Project	IEEE 802.16 Broadband Wireless Access Working Group < http://ieee802.org/16 >	
Title	Enhancements to the Message Transfers for the initialization of Scan, Sleep, and Idle Mode	
Date Submitted	2004-11-04	
Source(s)	Yongwon Kwak, Kiseon Ryu, Beomjoon Kim, Yongho (Ronny) Kim, and Changjae Lee, LG Electronics Inc., 533, Hogue-1dong, Dongan-gu, Anyang-shi, Kyongki-do, Korea	Voice: +82-31-450-4387 Fax: +82-31-450-7912 [mailto:{yongwon, ksryu, beom, ronnykim, cjlee16}@lge.com]
Re:	Response to Sponsor Ballot	
Abstract	This document contains suggestions to enhance message transfers for initializing Scan, Sleep, and Idle Mode.	
Purpose	Adoption of proposed changes into P802.16e	
Notice	This document has been prepared to assist IEEE 802.16. It is offered as a basis for discussion and is not binding on the contributing individual(s) or organization(s). The material in this document is subject to change in form and content after further study. The contributor(s) reserve(s) the right to add, amend or withdraw material contained herein.

Enhancements to the Message Transfers for the initialization of Scan, Sleep, and Idle Mode

[In 6.3.19.1 Figure 130b-MSS Awaiting Sleep Response SDL Diagram, page 106, modify the following Figure as]:

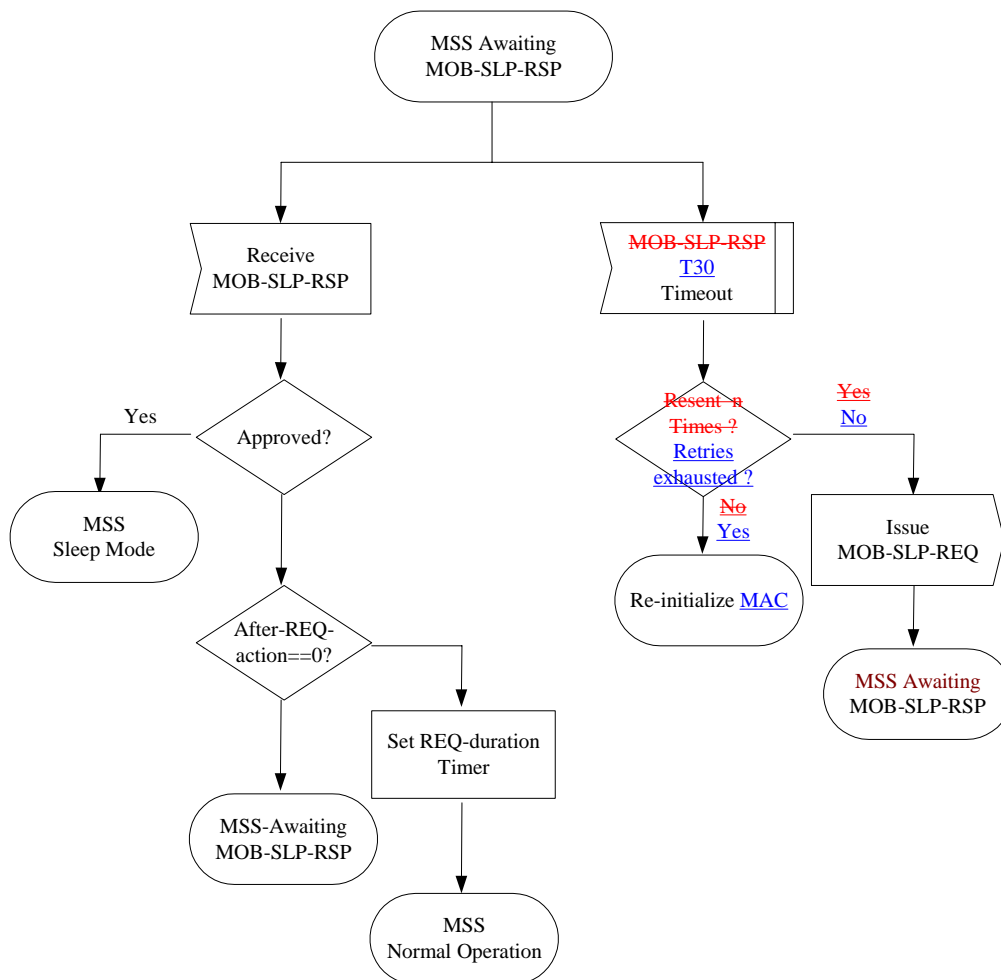
Add the text to describe the procedure to retransmit MOB-SLP-REQ message, while a retry count is not exhausted if an MSS sent a MOB-SLP-REQ message to a BS and did not receive a MOB-SLP-RSP message within a specified time, and modify Figure 130-b.

Before entering Sleep Mode the MSS shall inform the BS using MOB-SLP-REQ and obtain its approval. The BS shall respond with an MOB-SLP-RSP message. If the MSS does not receive the MOB-SLP-RSP message within T30 timer expiry after it sends the MOB-SLP-REQ message to the BS, the MSS shall retransmit the MOB-SLP-REQ message as long as

retry count has not been exhausted. Otherwise, the MSS shall re-initialize MAC. The Serving BS may send an unsolicited MOB-SLP-RSP to the MSS to initiate MSS Sleep Mode. After receiving an approving MOB-SLP-RSP message from the BS, an MSS shall enter Sleep Mode at the appropriate frame prescribed by the message.
